Noncompliant Weld Inspection Techniques

Line 114 Non Destructive Examination Final Report

Issue Date December 5, 2013

Figure 2 – Weld 270 Indication with measurement inset showing length of 0.157” (3.9mm)

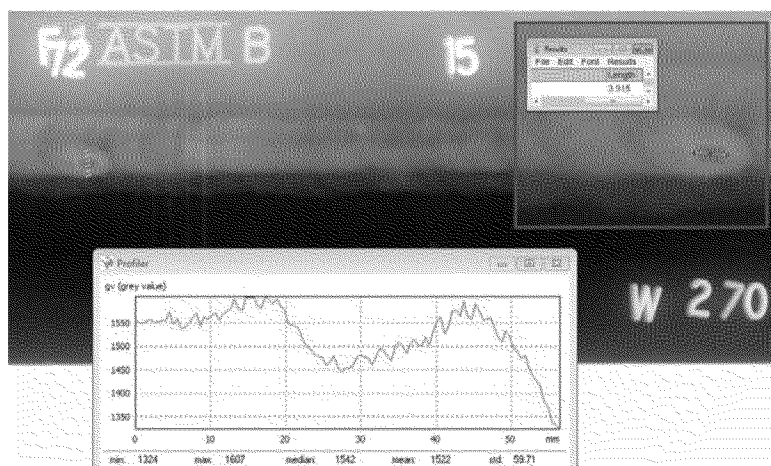
- 3.1 Weld 270, digitized in the region of interest is depicted in Figure 2. Here it can be seen, due to low change in density which is less than the adjacent parent material, and the presence of a halo, that the indication is one of Burn-Through (BT), and is acceptable per section 9.3.7 of API-1104. The weld repair process confirmed this result where the indication was found at the root.

Figure 3 – Weld 311 with acceptable BT length of 0.141” and acceptable small pores

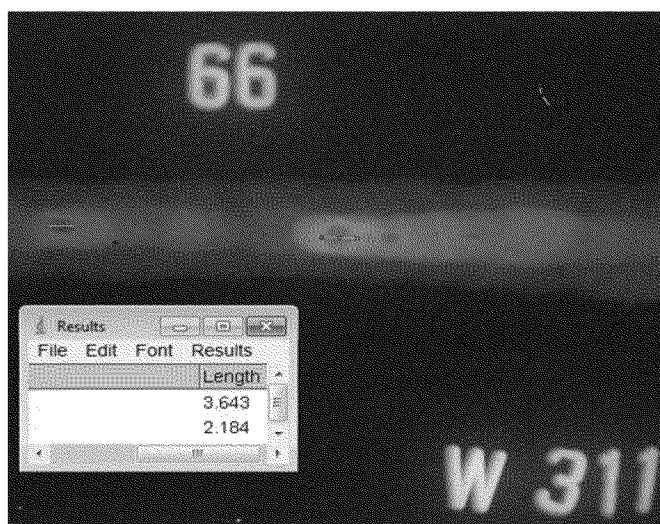
3.2 Weld 311, digitized in the region of interest, is depicted in Figure 3. Similarly we have one indication of burn-through and 3 small pores, all of which are acceptable per sections 9.3.7 & 9.3.9 of API 1104. For both welds 270 and 311, the repair process had to proceed to the root before the indications were eliminated, confirming that they were caused by burn through.

Figure 4 – Weld 162 with acceptable indications of undercut

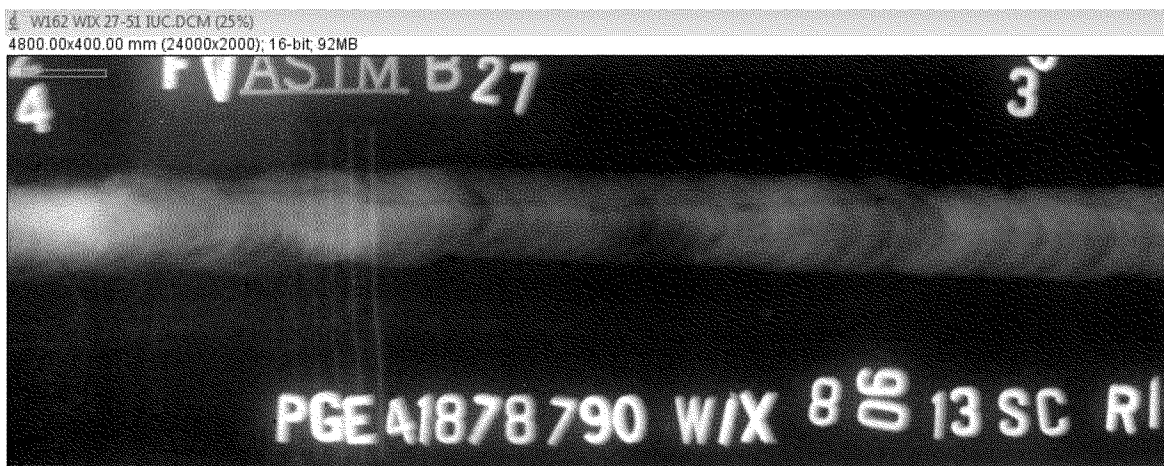
3.3 Weld 162 indication was digitized as shown below in Figure 4. Radiographic density measurements indicate that no portion of the indication has an indication of undercut which is greater than 0.016” deep, indicating that it is acceptable per section 9.3.11& 9.3.7 of API 1104.

Figure 5 – Measured IUC on W162 depicted in Figure 4

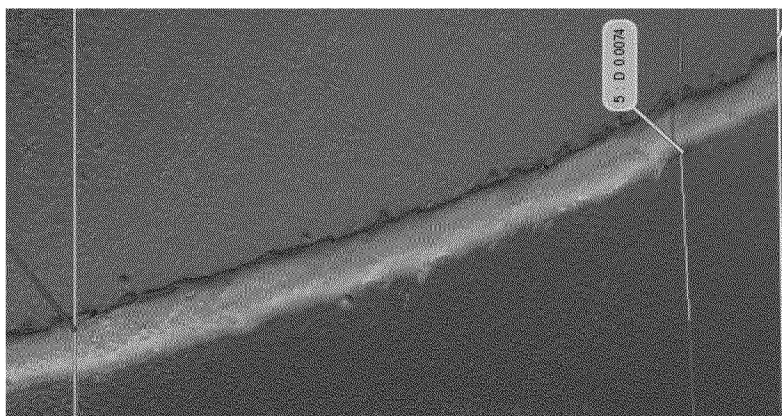
- 3.4 To validate the digital radiographic measurements, external visual, UC gaging and dial indicator measurements revealed that only small areas within the called ROI (25-29) had bottoms estimated below the adjacent parent material surface. Measurements had thus low repeatability due to topography. This result led to the decision for the Creaform photogrammetry with its calibrated 40 micron spatial resolution and accuracy to within 0.002”.
- 3.5 Creaform photogrammetry results were obtained for the radiographic ROI (25-29 in Figure 4). The measurements confirm that no portion of the indicated area of concern radiographically, has a depth greater than 0.016 inches, and is therefore acceptable per sections 9.3.11 & 9.7. Figure 5 below depicts worst case of 0.0074” in radiographic ROI.

Figure 1 – Assessment of Weld 760 IUC region of interest

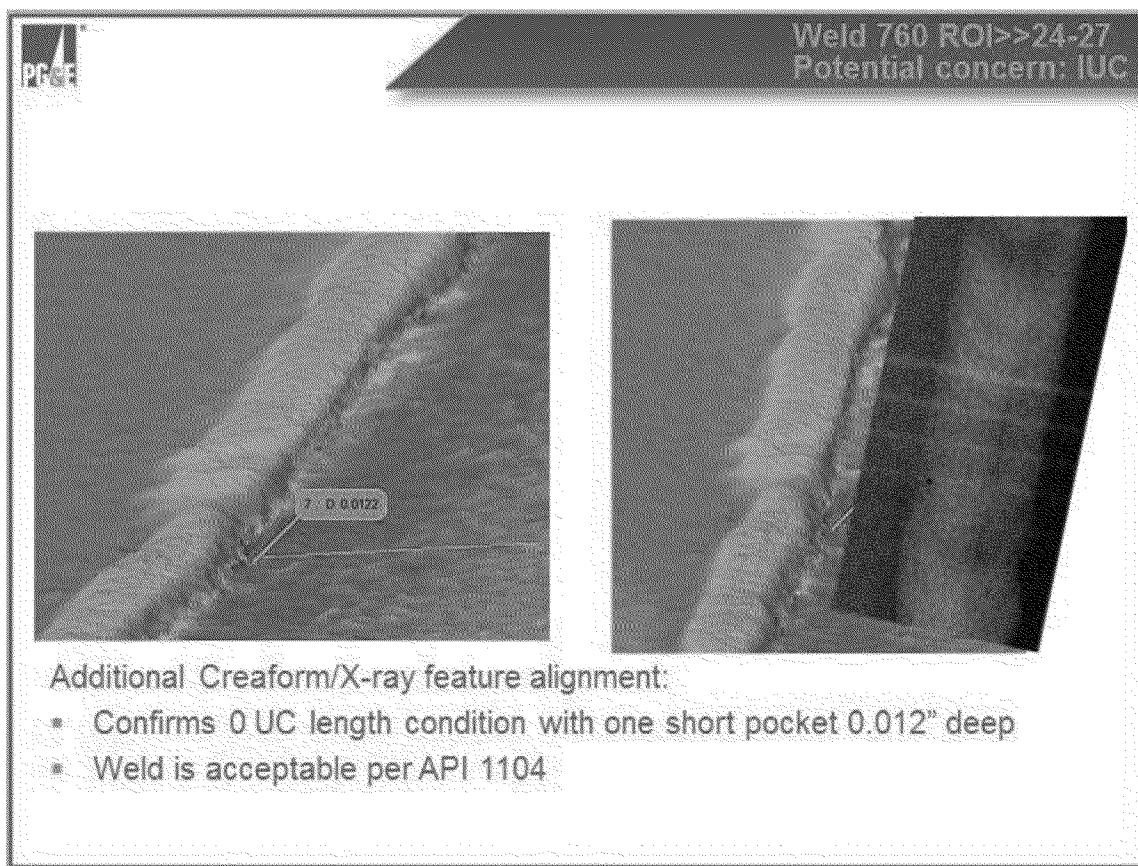
3.5 Creafom photogrammetry results were obtained for all the radiographic ROI's. The criteria applied to these results were API 1104 section 9.7, Table 4, "Maximum Dimensions of Undercutting". Applying the further criteria of depth from this requirement, to the documented radiographic and visual measurement data for length, all welds were found acceptable. Figure 2, from slide 5 in Appendix I, summarizes the typical physical condition for the audit identified indications of concern.

Weld 760 cited for indications of internal undercut from 24-27

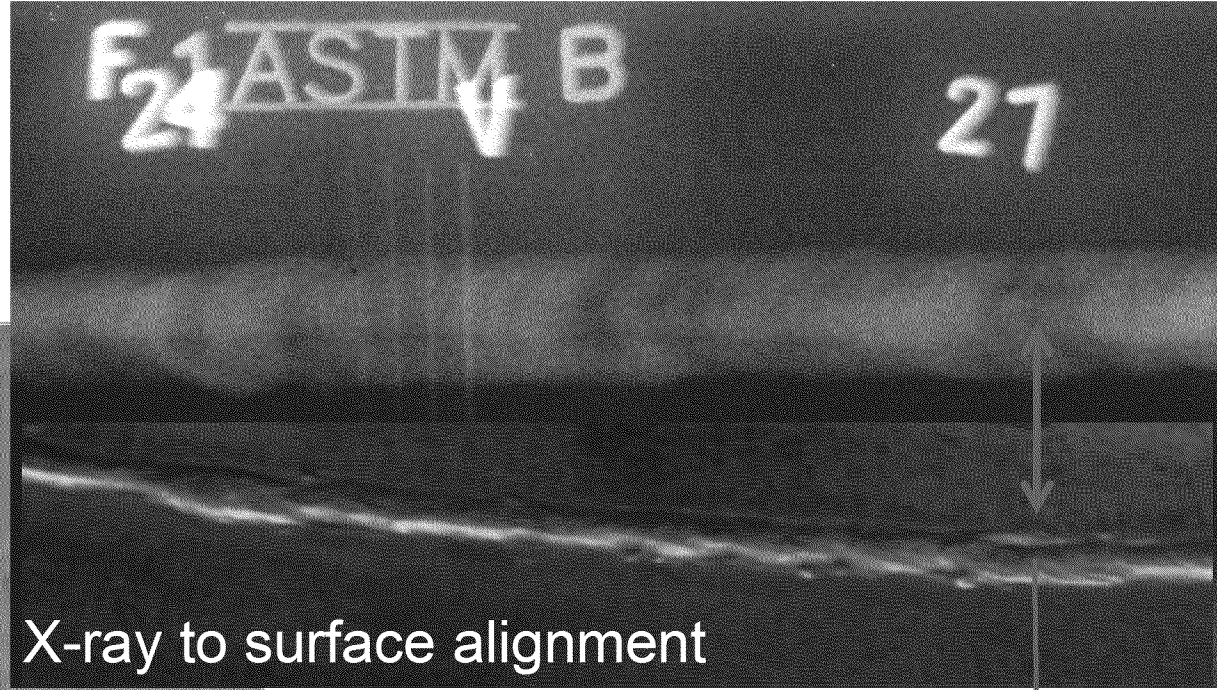
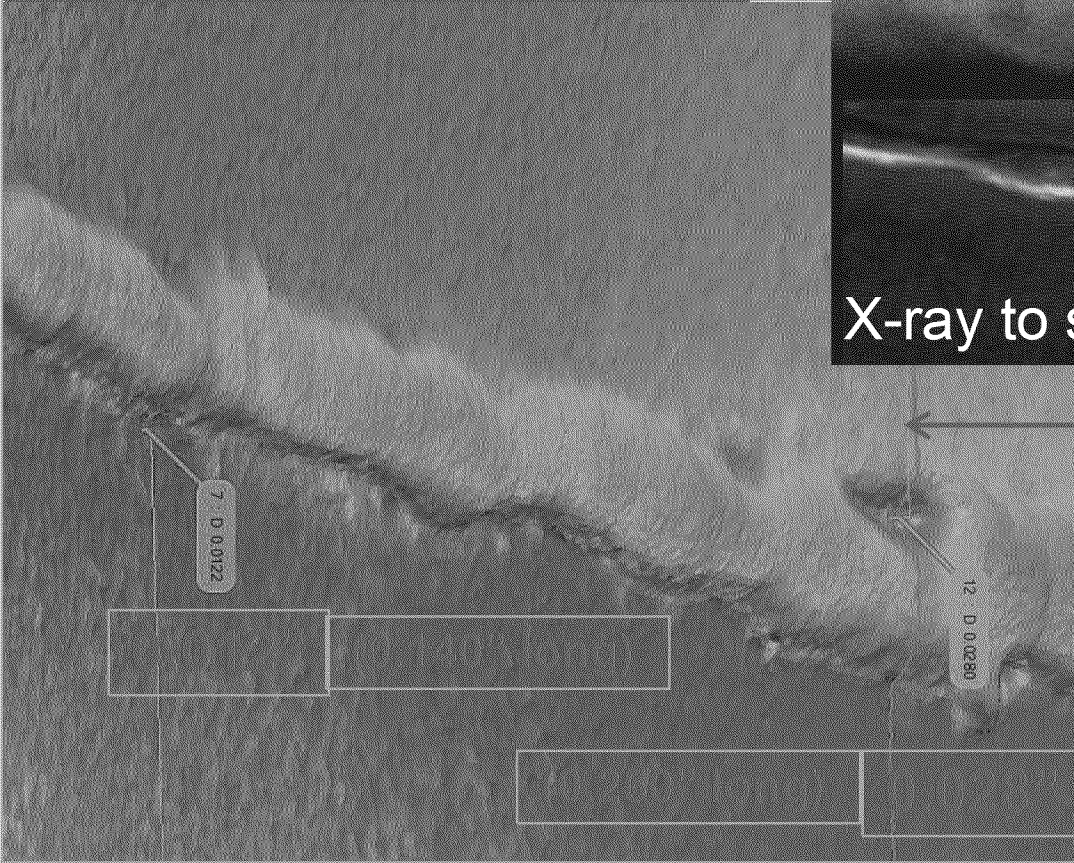
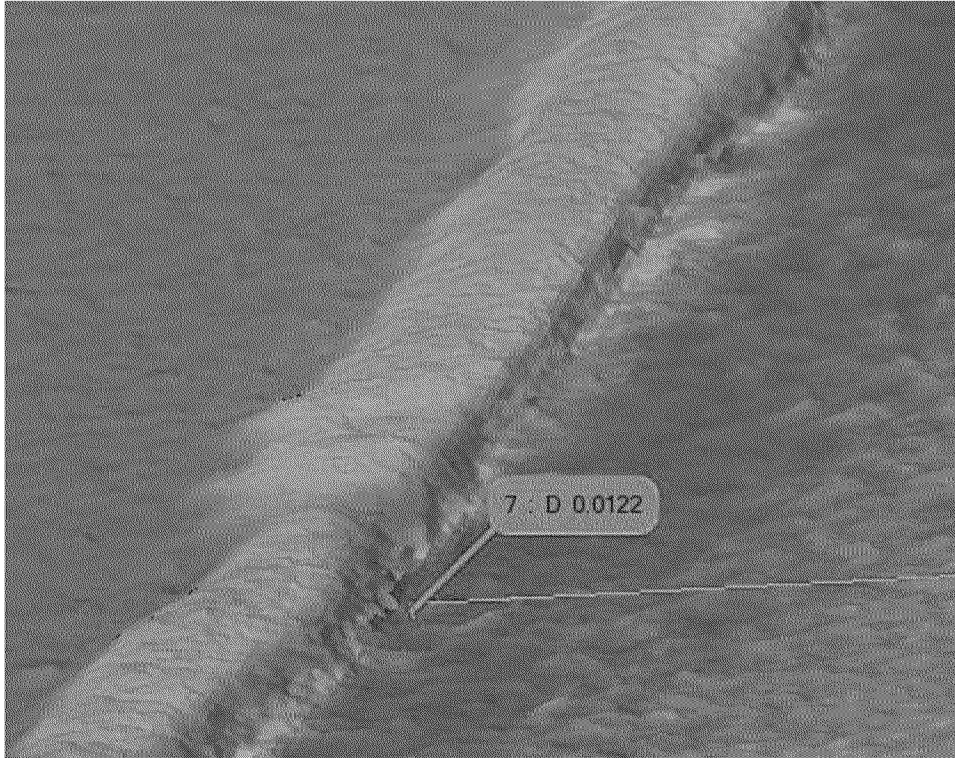
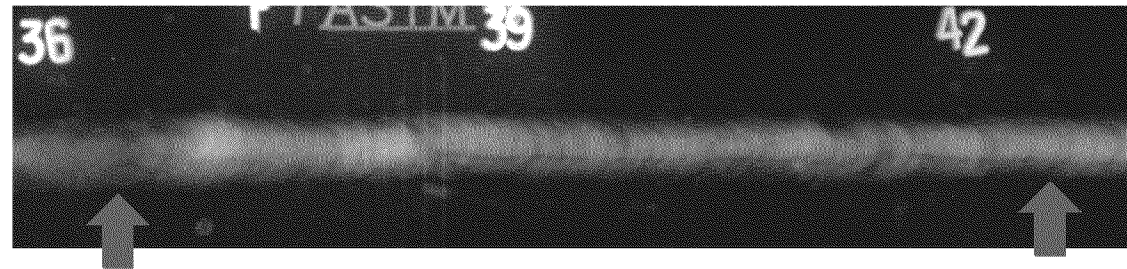
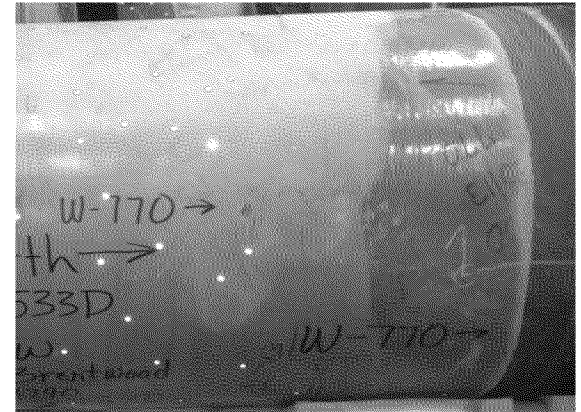
Depth of most severe indications estimated by change in x-ray density

RT estimated depths of 0.012 – 0.028 inches

Confirms indications are mostly diffraction effects on minor hi/lo condition with 0 UC

Two small pockets are 12 and 28 mils deep with greatest length of 0.250"

Weld is acceptable per API 1104

Weld 770 cited for indications of internal undercut from 36-42
Excised weld photo-documented and ROI aligned with weld features
Depth of most severe indications estimated by change in x-ray density

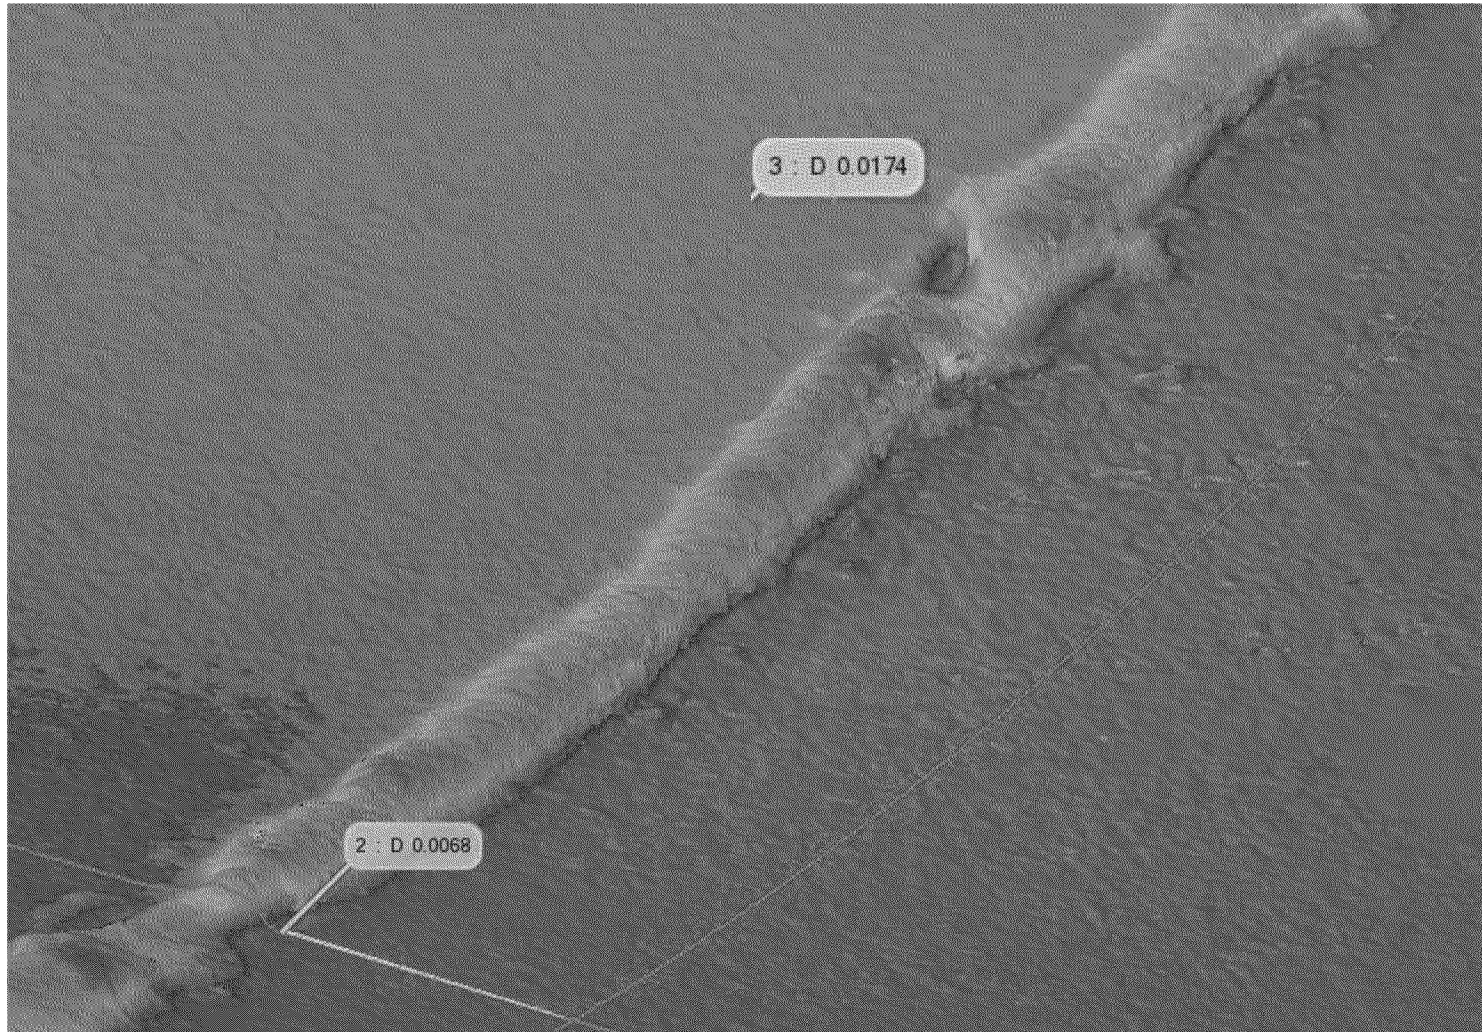
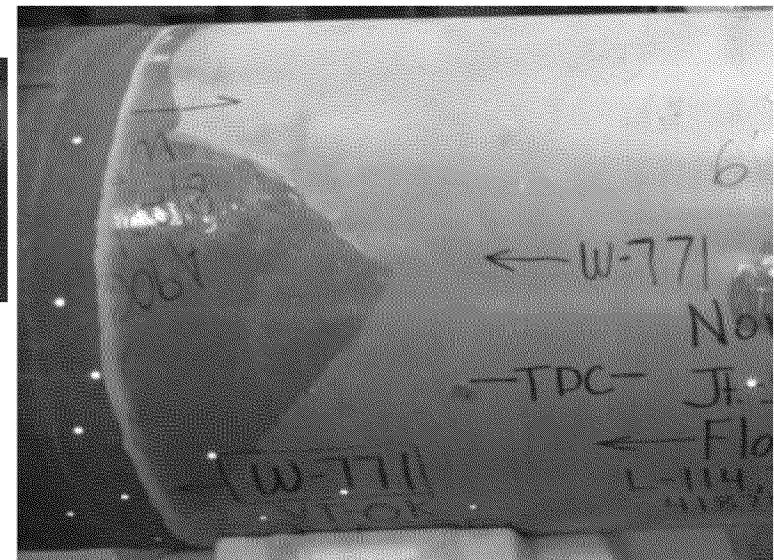
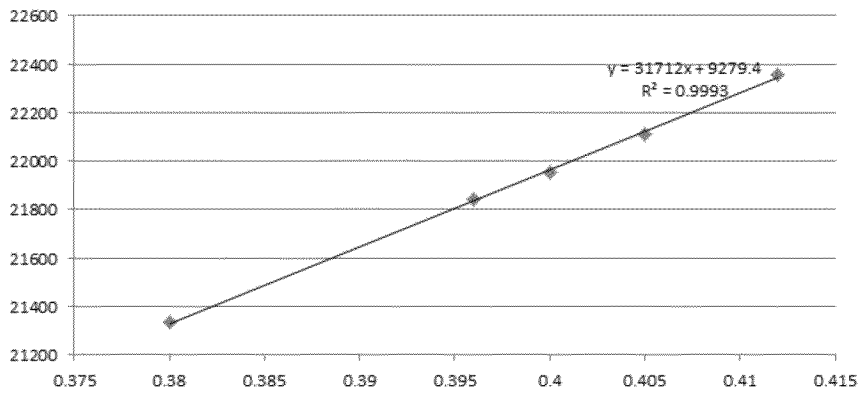
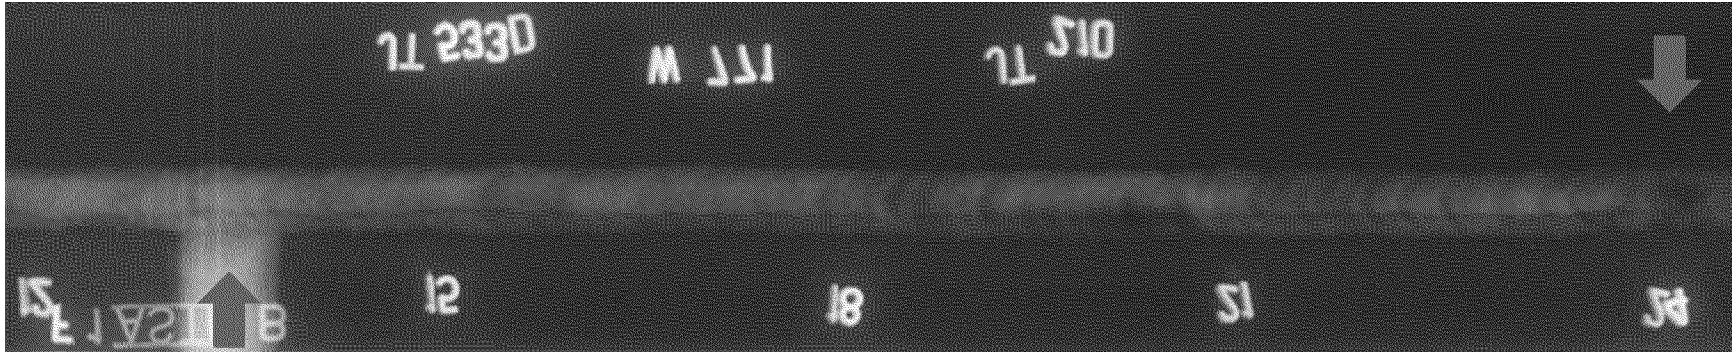
RT estimated depths of up to 0.008 inches

- Confirms indications are, in the majority, diffraction effects on minor hi/lo condition with 0 UC
- One small pocket observed at 0.007" deep x 0.130" long
- One unrelated pocket opposite ROI of 0.017" deep x 0.195" long
- Weld is acceptable per API 1104

- * Confirms UC indication is diffraction/"shadowing" from high/low condition
- * Weld is acceptable per API 1104
